## #2019-91 Discount Tire – Preliminary PUD Project Review for Planning and Zoning Commission

<b><u>Meeting Date:</u></b>	July 3, 2019
<b><u>Request:</u></b>	Preliminary Planned Unit Development for a new 8,192 square-foot retail building.
<b><u>Location:</u></b>	5501 Northwest Highway
<b><u>Acreage:</u></b>	Approximately 2.1 acres
<b><u>Existing Zoning:</u></b>	B-2 PUD General Commercial Planned Unit Development
<b><u>Surrounding Properties:</u></b>	North: B-2 PUD General Commercial South: M Manufacturing (Three Oaks Recreation Area) East: B-2 PUD General Commercial West: M-L Manufacturing Limited
<b><u>Staff Contact:</u></b>	Elizabeth Maxwell (815.356.3615)

**CONCEPTUAL COLORED ELEVATIONS**

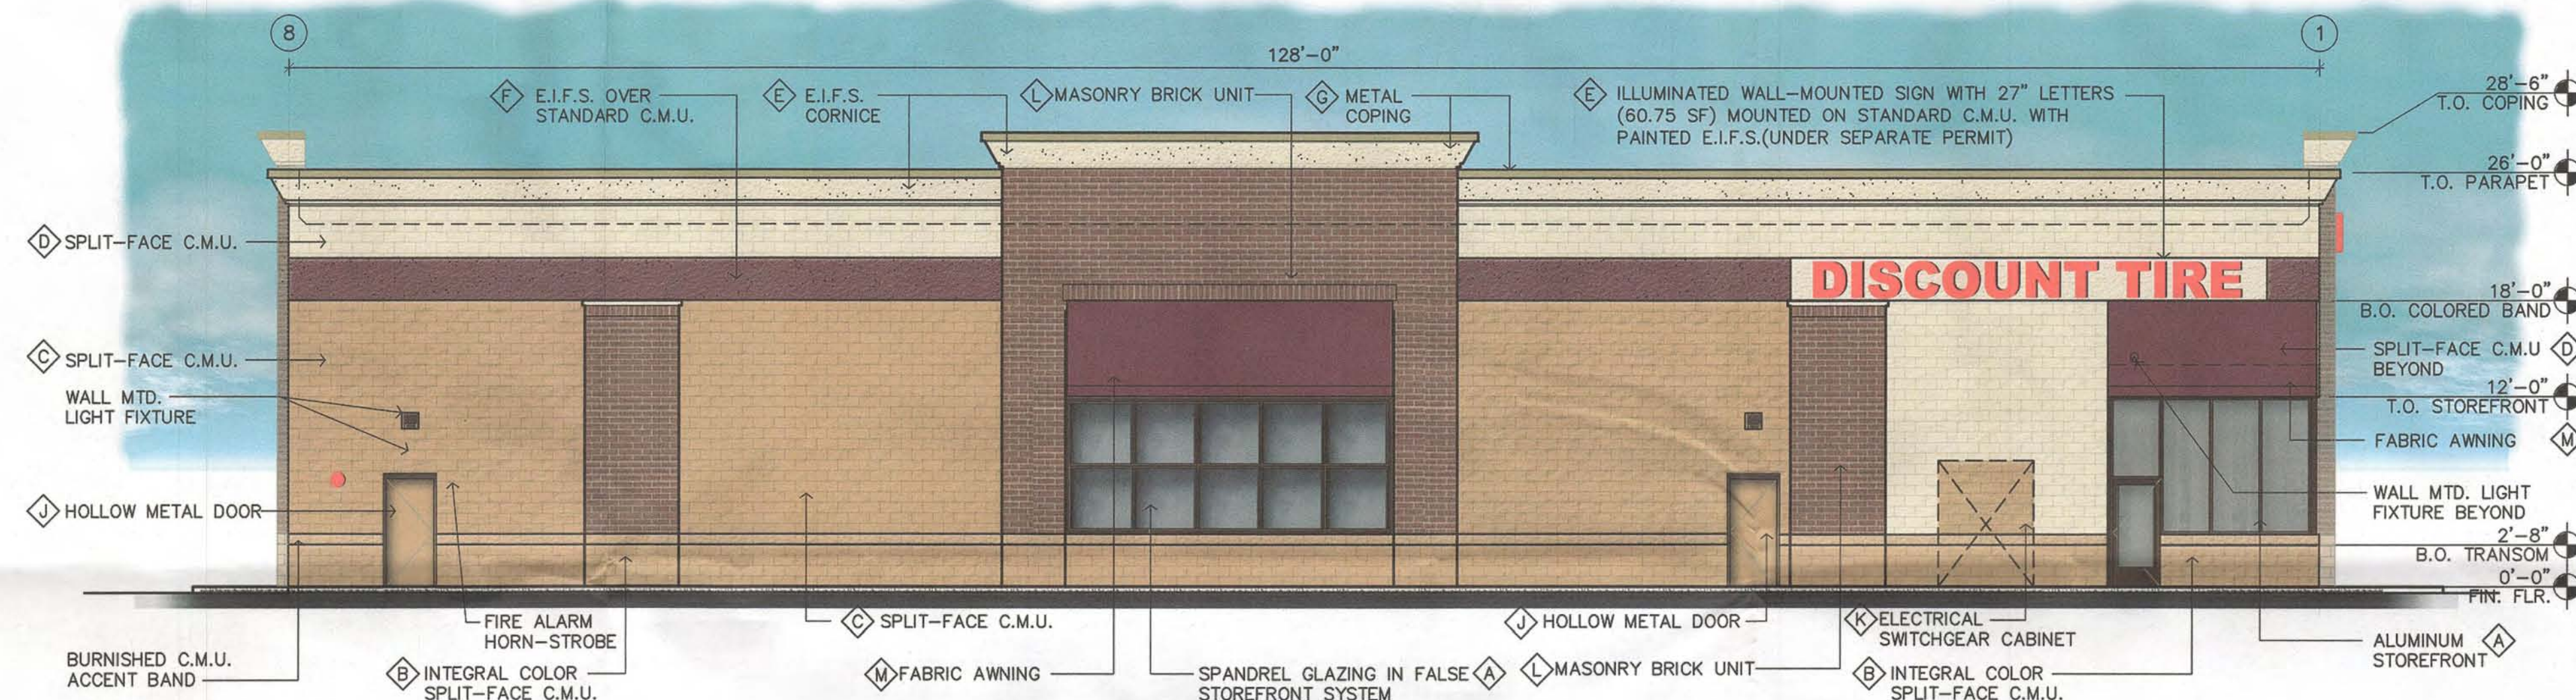
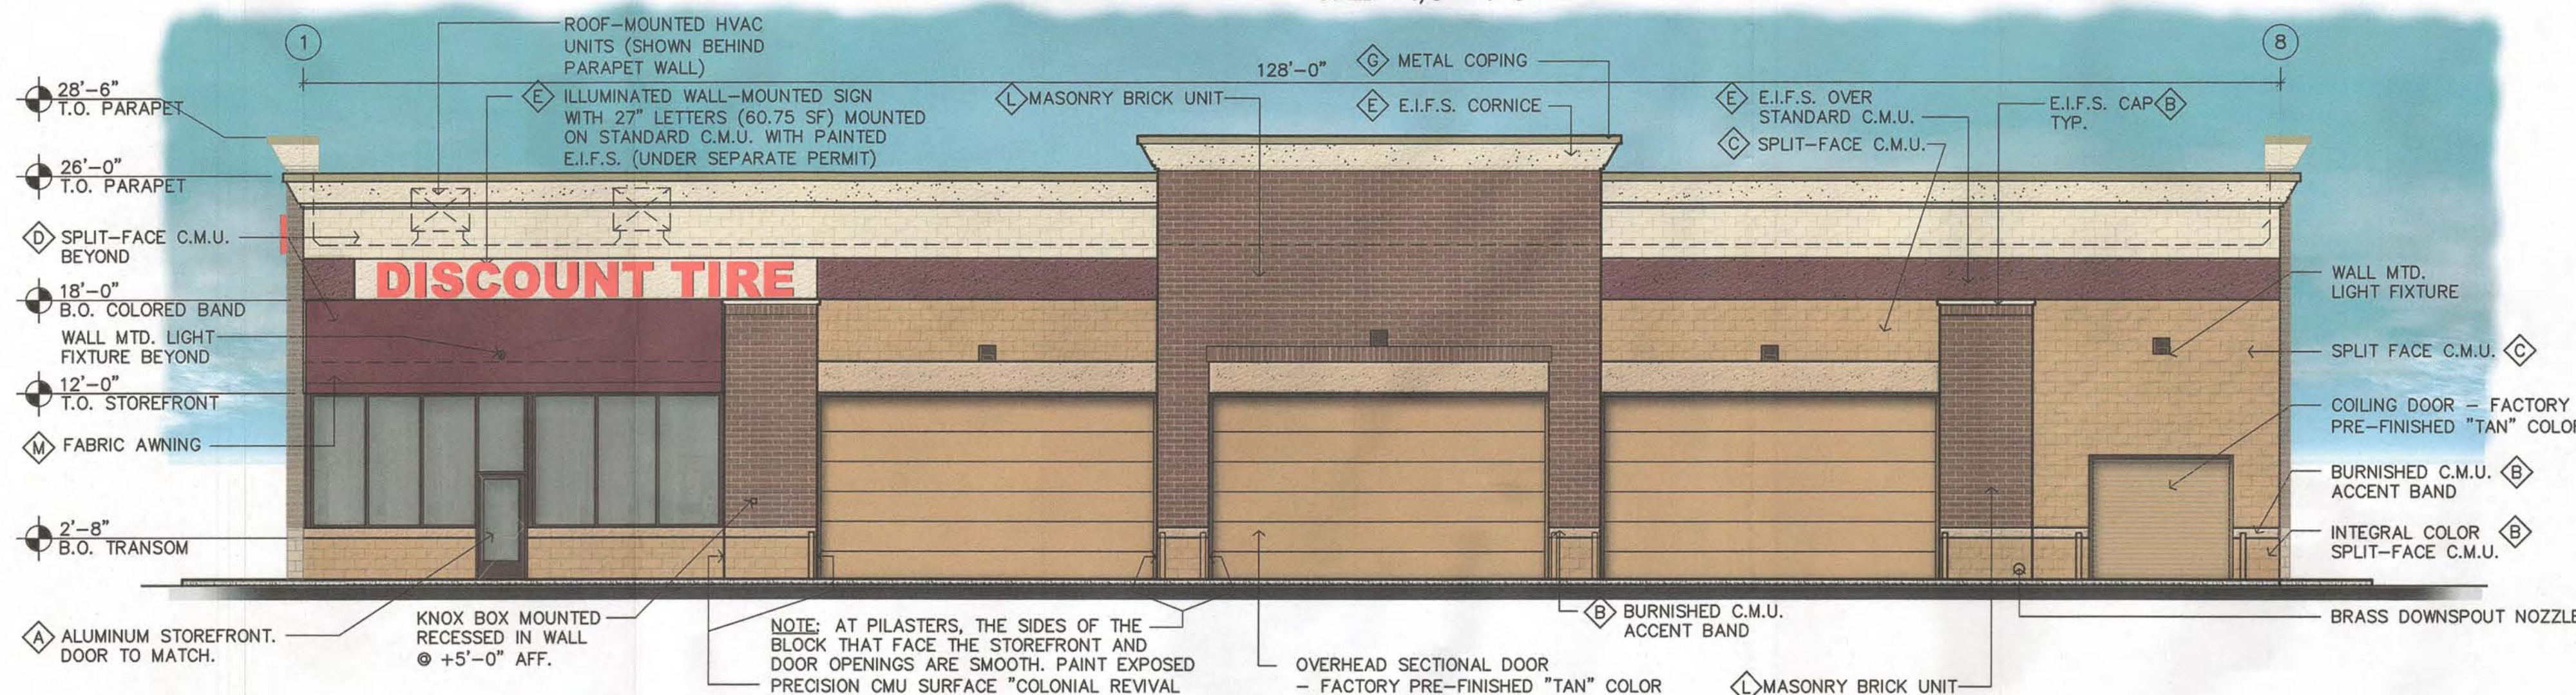
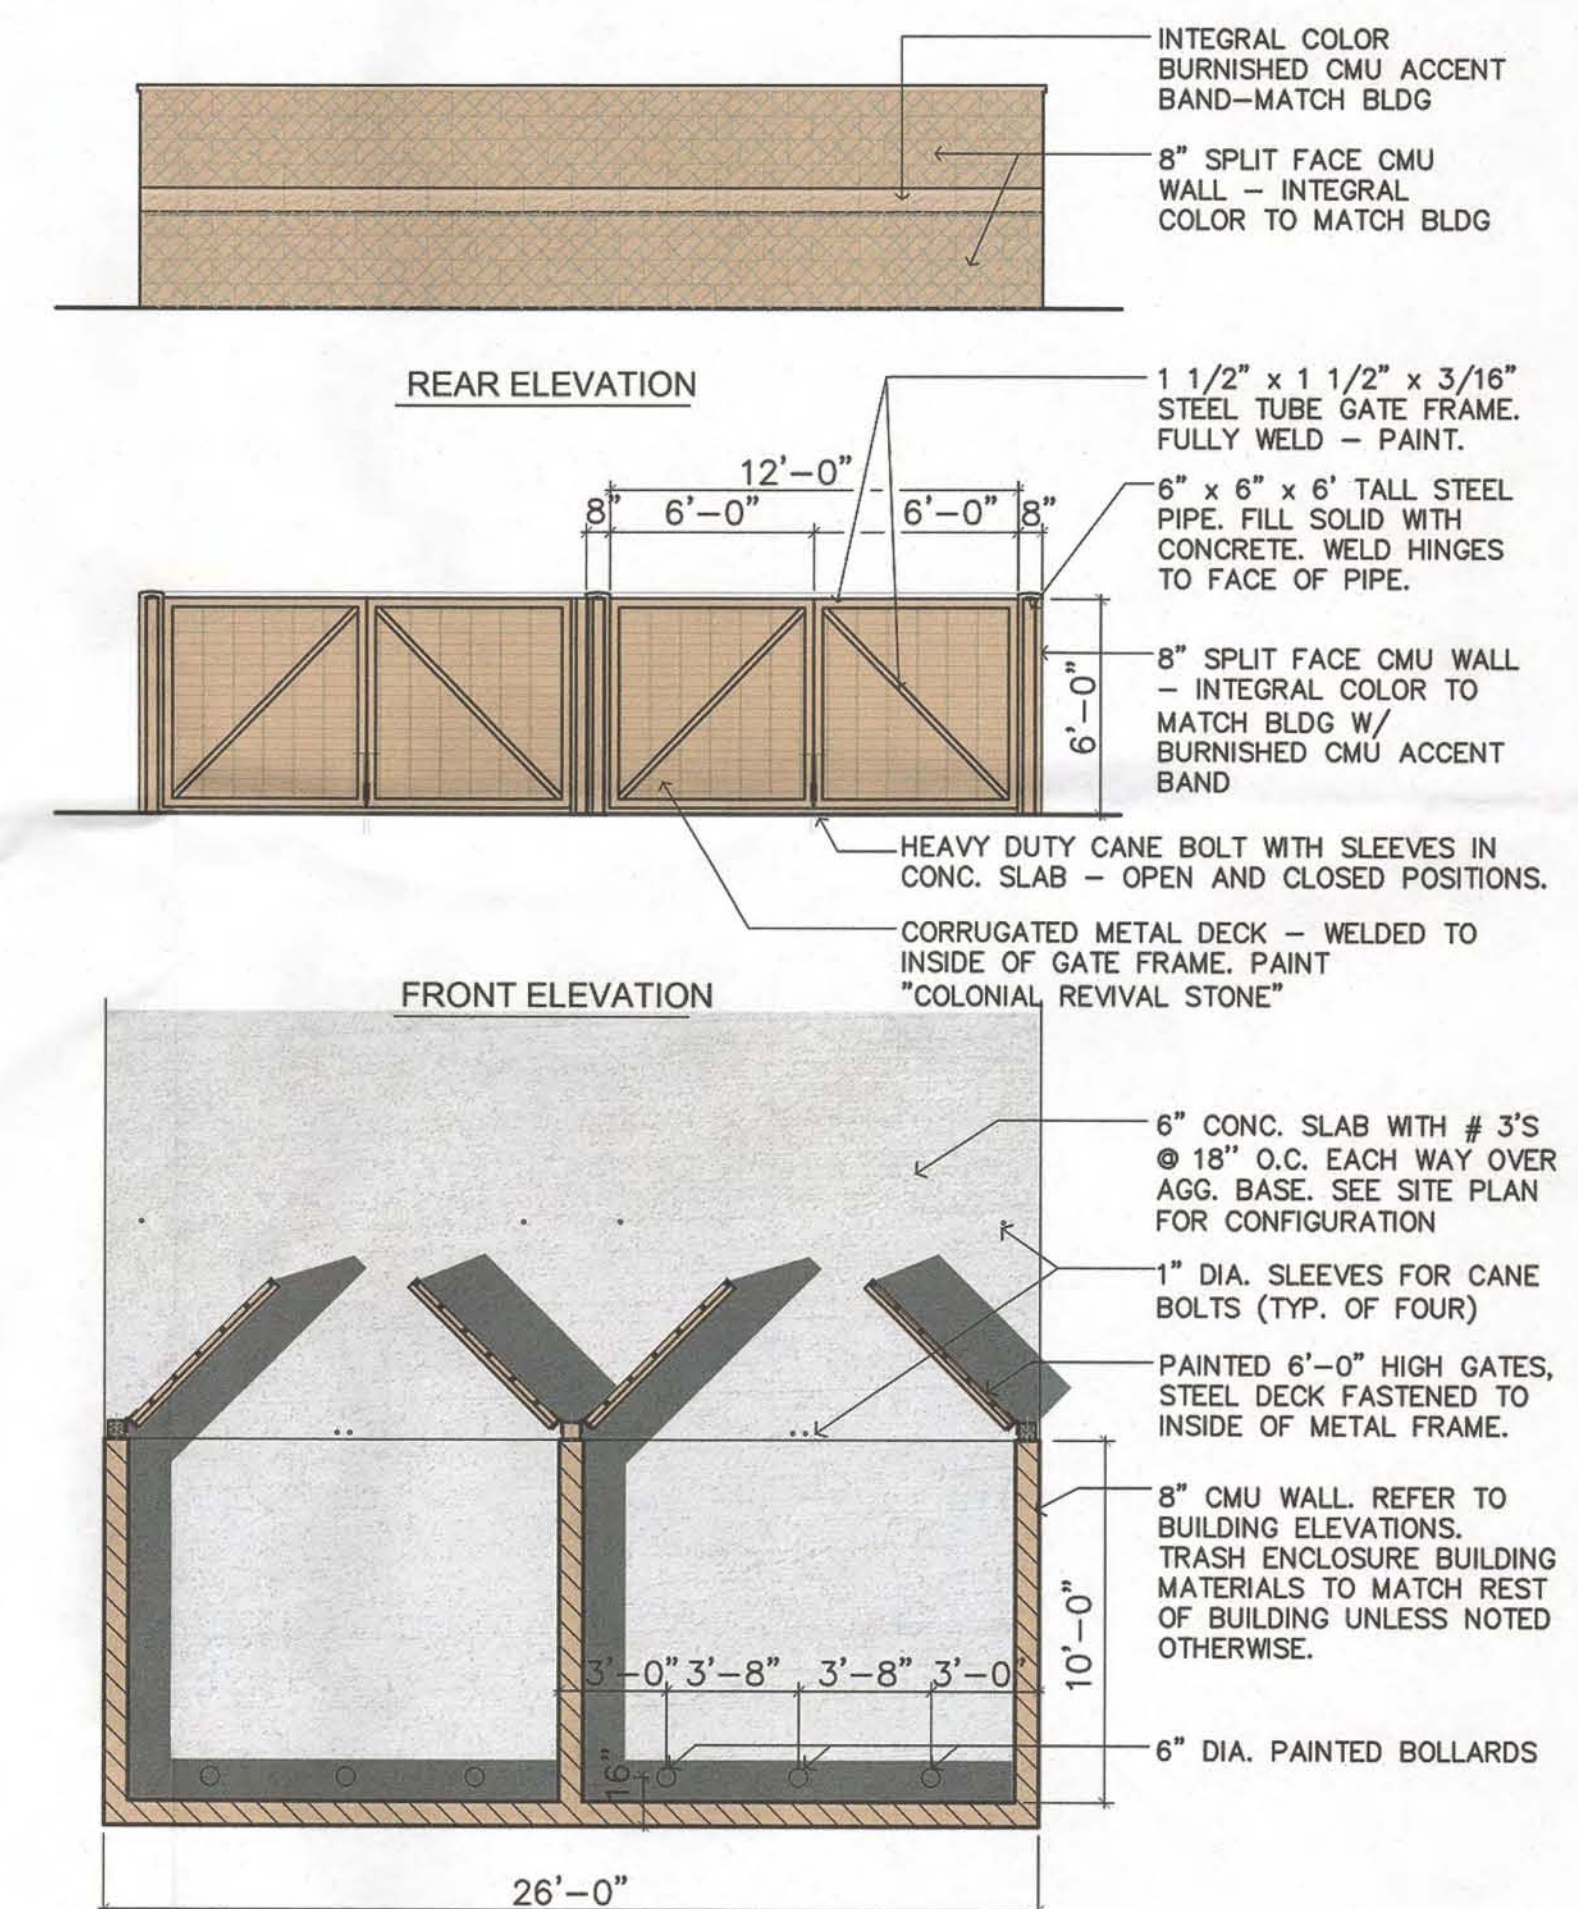
- Colonial Revival Stone colored CMU and Richfield colored brick comprise the majority of the exterior. Antique White colored CMU and EIFS provide accent trim colors and materials to the top of the building. A thicker dark Sierra Tan metal coping is provided to finish off the top of the building.

- The front elevation is accentuated with dark anodized framed window bays, which carry over to the side elevations. CMU block and accent ledge create a knee-wall so the windows do not go all the way to the ground.

- Red fabric awnings finish off the color palette and dress-up the window bays.
- The dock doors face an interior property line and with the building's setback from Route 14 they will be partially blocked by the adjacent building. The doors are solid steel.

- Staff has reviewed the elevations based on the criteria listed in the Design Standards. The project meets 6 of the 10 criteria. 6 of 10 are required to be considered meeting the design standards for architecture.

- Signage is illustrated on three sides of the building. The two signs on the sides of the building are 60.75 square feet each. The sign along the front elevation is 75 square feet.
- Free-standing buildings are permitted signage on all elevations that would total 150 square feet. The petitioner is requesting a variation to allow 196.5 square feet of total wall signage.

4. Elevations
  - A. The metal coping top cap shall project at least two inches above and out from the rest of the top parapet to provide additional height and width to the cornice.
